Report pursuant to s42A Resource Management Act 1991

In the matter of:	A Notice of Requirement to construct and operate a new intermodal rail and freight hub on land between Palmerston North and Bunnythorpe
And:	A hearing by Palmerston North City Council pursuant to s100A
Requiring Authority:	KiwiRail Holdings Ltd
Hearing date:	9 August 2021

S42A Technical Evidence: Noise

By: Nigel Lloyd

Figure 3. Areas Significantly Impacted by Construction Noise (ref Fig 11 of the Acoustic Assessment)

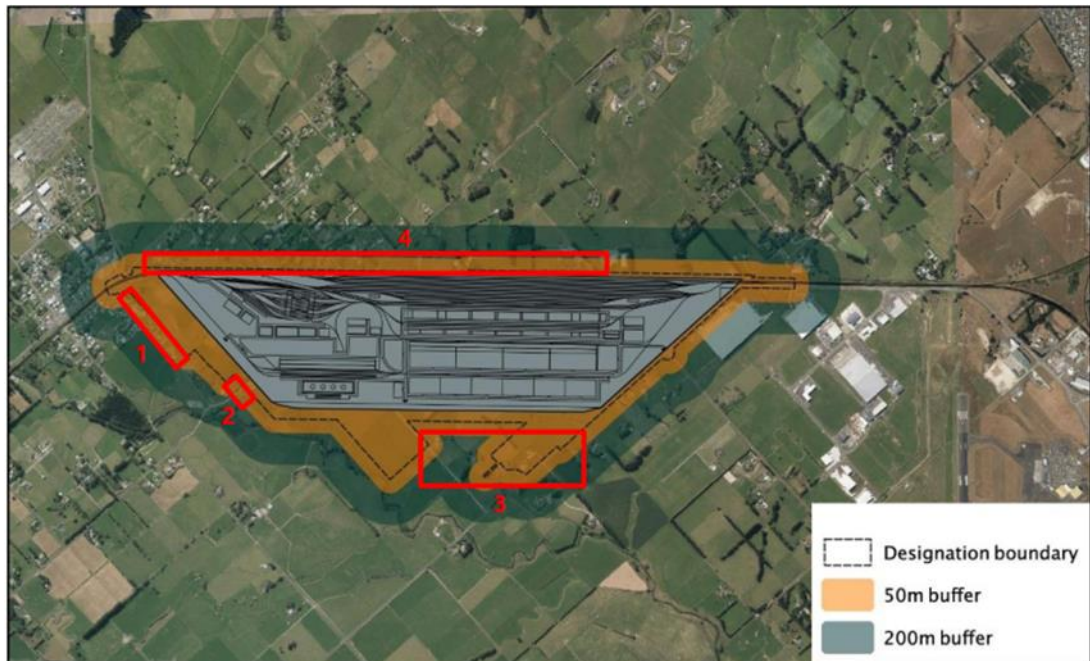
91. While this construction activity may be spread over a wide area, care should be taken that construction noise does not become regular at any one location, should haul roads pass close to dwellings, for example. NZS 6803 allows up to 70 dB L_{Aeq} to be generated at dwellings, and this would be an issue for the community if noise was to reach that level consistently over many years. The areas that are particularly vulnerable have been identified by the Acoustic Assessment at Figure 3 below.

92. It is not totally clear exactly which dwellings are included in the "buffer areas" shown in Figure 3, but my assessment is that the 50m buffer includes:

sequencing of the noise mitigation measures proposed should take these properties into account, e.g. whether noise barriers should be constructed prior to construction works commencing.

Figure 4. Construction Noise Buffer Areas (Figure 11 of the Acoustic Assessment)

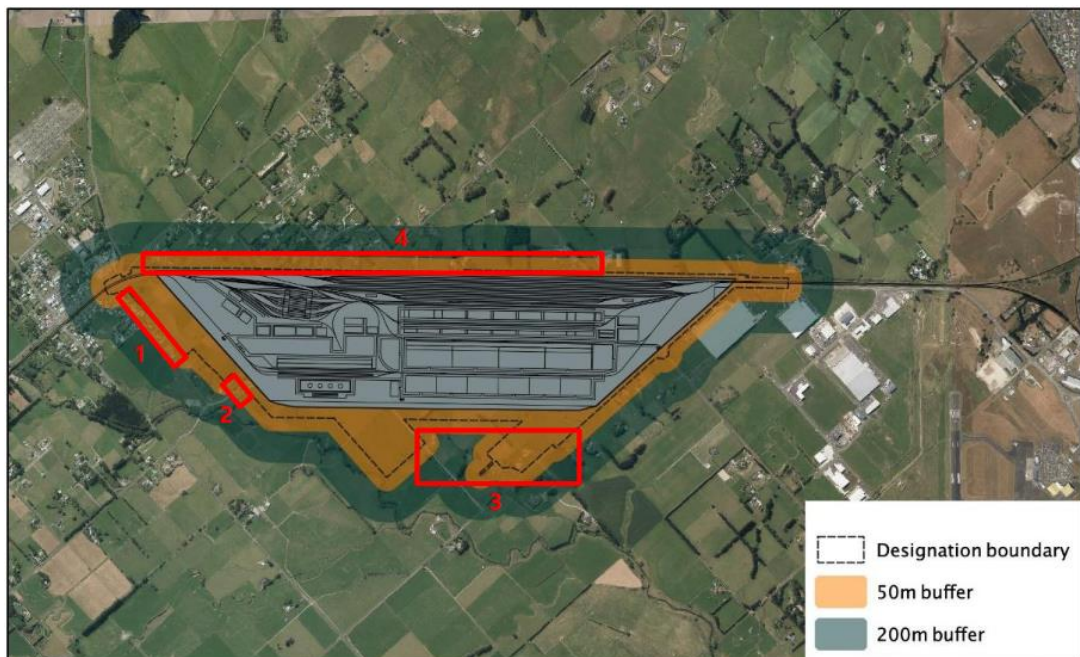
115. These four areas are marked in red in Figure 4 below.

116. It is difficult to ascertain exactly which dwellings are impacted by construction noise from Figure 4 but the Chiles response dated 12 February 2021 provides different sections at 1:5000 scale which provide much greater detail.

117. Construction Noise Area 1 is for dwellings on Maple Street. The nearby construction works identified in the Acoustic Assessment are relatively short-term, involving the construction of the permanent noise barrier and associated planting. This work should only occur during daytime.

Figure 6. Extract from Response to RFI for Section Through #90 Sangsters Road

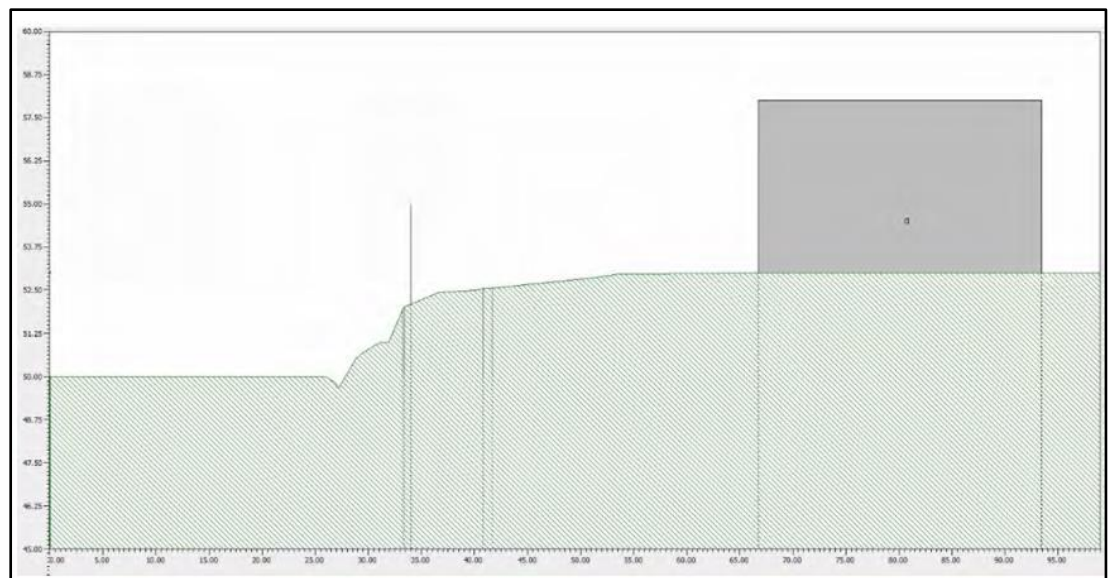
131. Turning to the uncertainty I have regarding Sangsters Road, Figure 6 was provided as part of the Response and shows a cross section through the proposed elevation of the Freight Hub (to the left) and the dwelling (to the right). I take it that the vertical line is what is being modelled as the 5m high acoustic barrier. My concern is that the windows of the dwelling would have line-of-sight into the Freight Hub and the barrier will therefore not be effective at screening the Freight Hub (and NIMT) noise.

132. I have a similar concern with the other cross section shown in Figure 11 of the attachments to the Response for 27 Sangster Road. While this dwelling is

Figure 7. 55 dB LAeq(1h) Noise Management Boundary (from Chiles Response 12 February 2021)

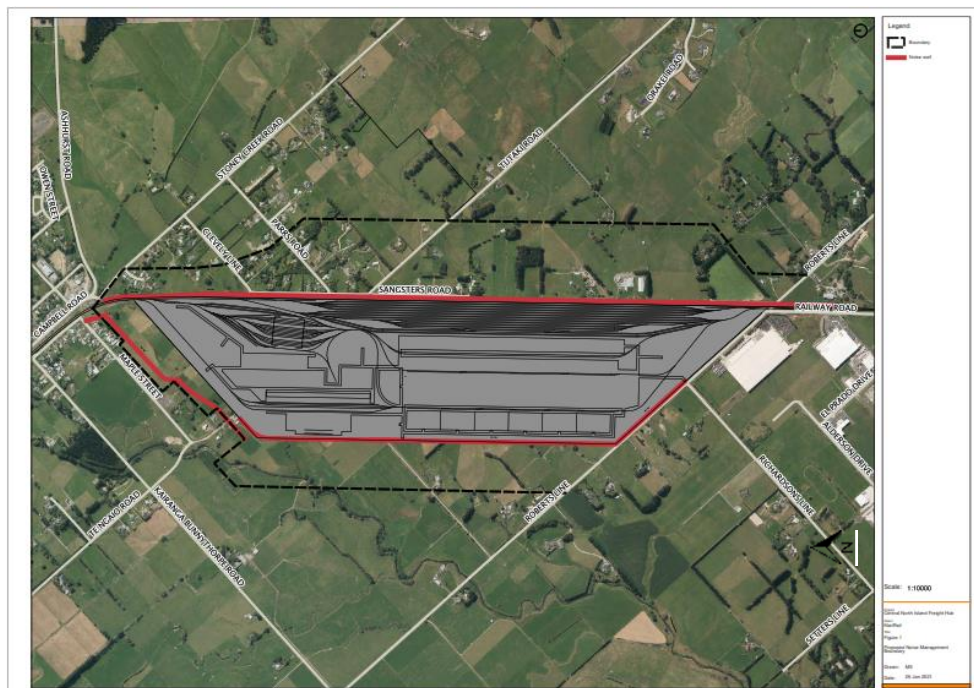
205. The critical point about the land between the 55 dB $L_{Aeq(1h)}$ noise management boundary and the designation boundary is that all houses on that land will be exposed to allowable noise levels that exceed the Category C night-time criterion and will be exposed to noise levels that are likely to be incompatible with residential activity. These houses can be noise insulated and mechanically ventilated to help protect against sleep disturbance, but they will be significantly impacted upon by noise.

206. Given that the Freight Hub is to operate on a 24/7 basis for 365 days of the year, then a single noise management boundary is theoretically appropriate but must be designed to protect against night-time noise.

Figure 8. Indicative noise contours with noise barriers (Acoustic Assessment Fig 12)

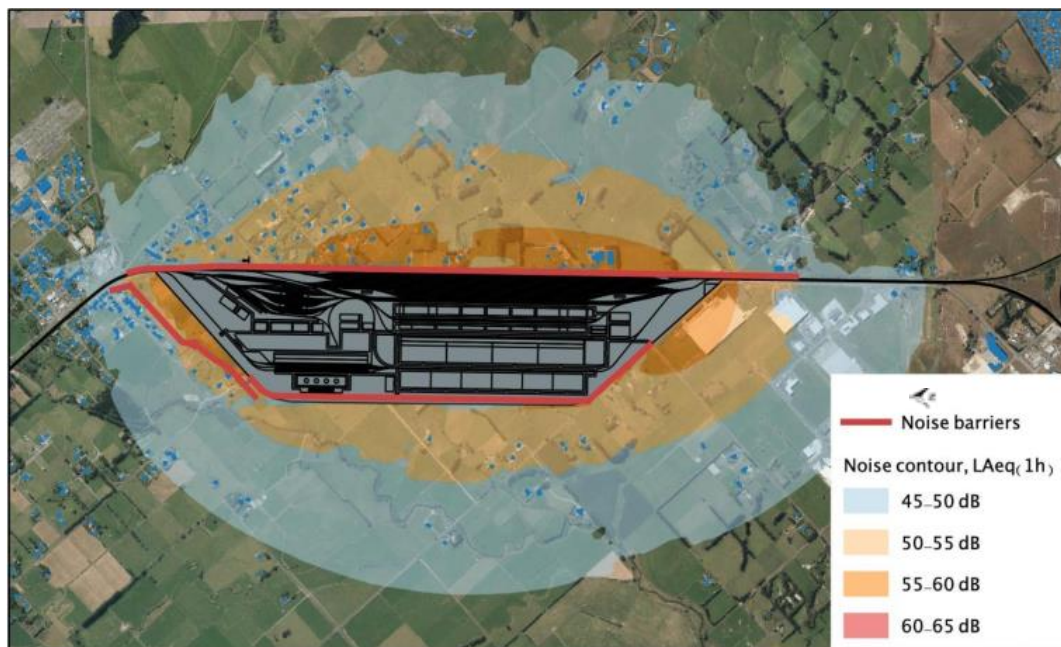
208. The noise modelling contours in Figure 8⁴⁵ shows the extent of the 45 dB $L_{Aeq(1h)}$ contour for a *busy hour*. If the *busy hour* was to occur at night, then the outer edge of the contours indicates the extent of the night-time noise impact.⁴⁶

209. Figure 8 is difficult to read and a series of 1:10,000 plans are shown as part of the Chiles response dated 12 February 2021 on which individual dwellings can be identified.
